WOODRIDGE LODGE
LOT 619, DP 1118588
WOODRIDGE, THREDBO VILLAGE

SECTIONS

issue no: DA2

drawing no: DA30

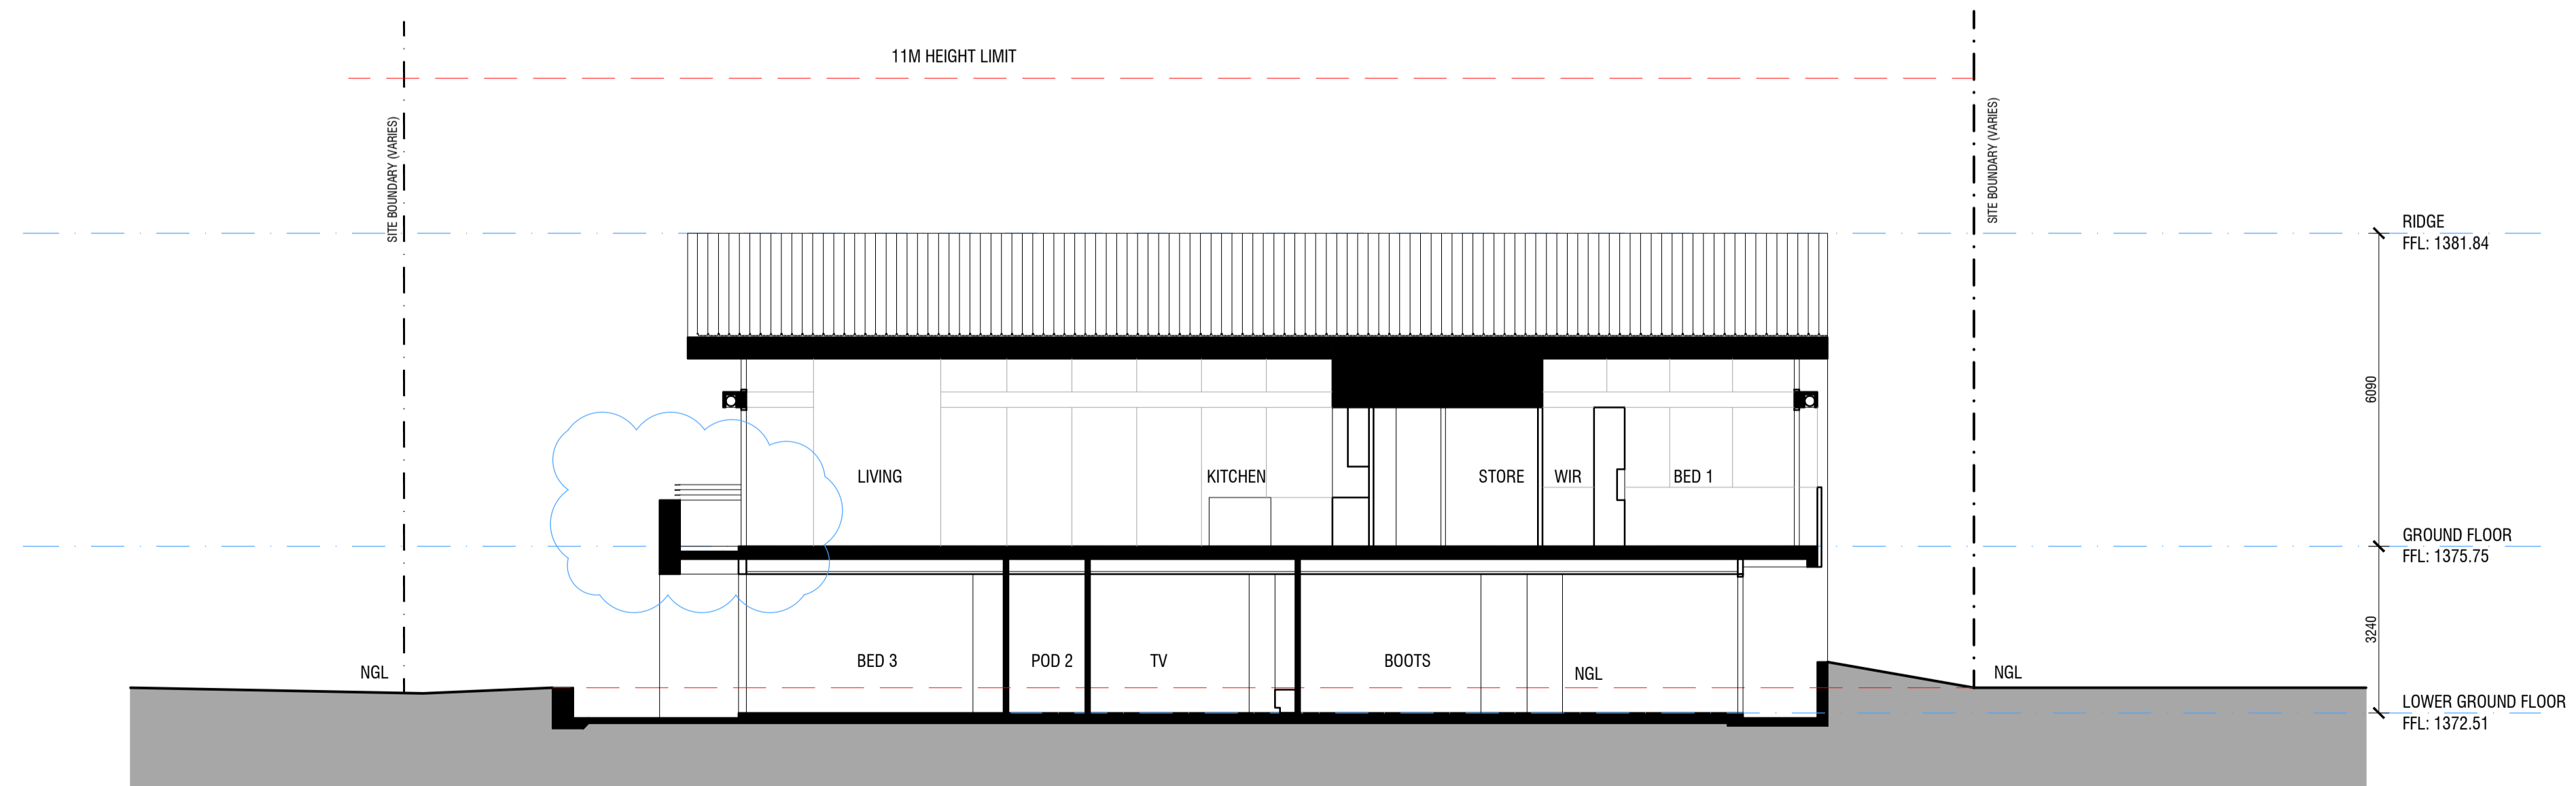
- ADDITION OF NOTES
- TERRACE BALUSTRADE LIFTED BY 200mm
